**Kugaaruk Sewage Lagoon
Dam Safety Review**

(FINAL)

Prepared for:
Government of Nunavut
Community and Government
Services

March 24, 2017

Figure 3-5: Typical Berm Section (Extracted from Construction Drawing No: 201)

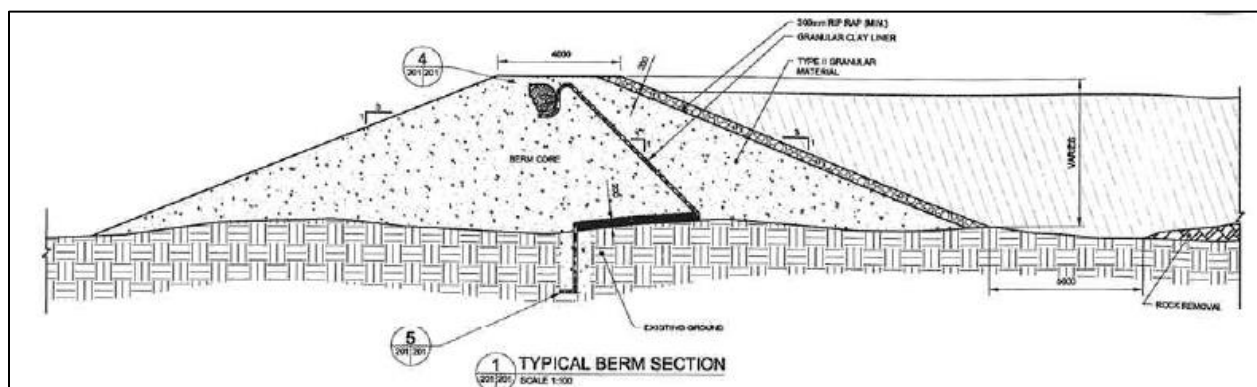
AMEC (2005) proposed three approaches for the construction of the lagoon. The selected option comprised placement of sand fill, which was allowed to freeze in place. A typical section is presented in **Figure 3-5**. The berm was designed with 3H:1V side slopes with specified Type II Granular material. The topographic survey completed by Stantec confirmed that the as constructed side slopes are 3H:1V on average.

The 'core' of the berm was separated from the upstream zone of the berm by a '*granular (sic) clay liner*'¹ or '*bentomate liner*', which to be was placed at 1H:1V and embedded in a 2 m deep by 1 m wide excavated cut-off trench. AMEC (2010) noted that the liner was a '*Bentofix Thermal Lock Geosynthetic Clay Liner*'. The berm was to be protected by rock armour, which was won from the excavations for trenches.

Figure 5-1: Potential flow-paths from a dam breach

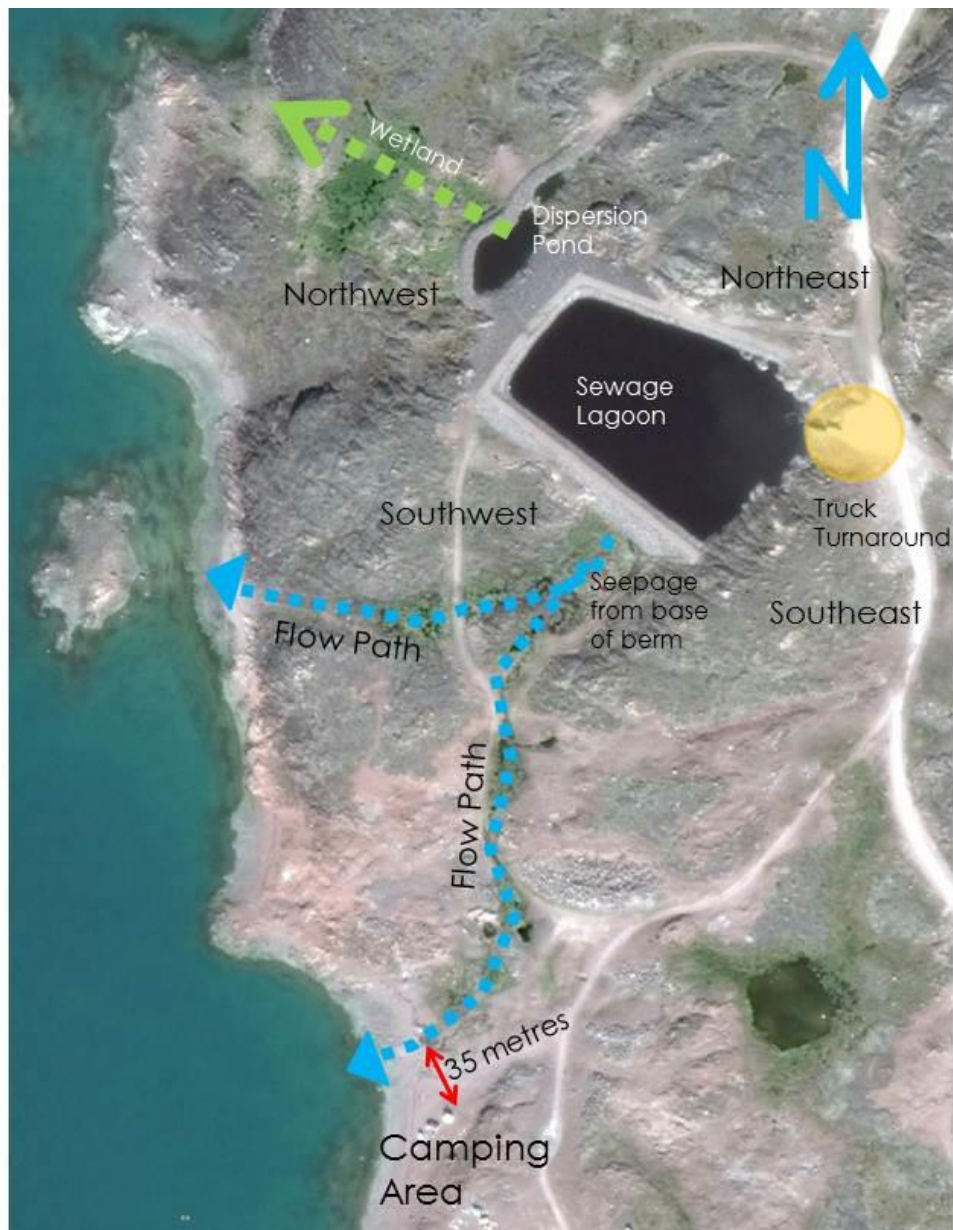
An advanced dam breach analysis and inundation mapping has not been undertaken for this DSR. However, the site inspection indicated that there are two potential inundation paths. These would occur due to a breach and release of fluid from the southwest and northwest berms. The topography on the northeast and southeast sides would restrict the flow. The flood wave would flow in a southwest or northwest (normal discharge path) direction towards the Pelly Bay (Figure 5-1).

It is recommended that the Kugaaruk Lagoon be classified as a '**significant**' consequence structure (see CDA Consequence Classification Rating table in Appendix). This is based on the following:
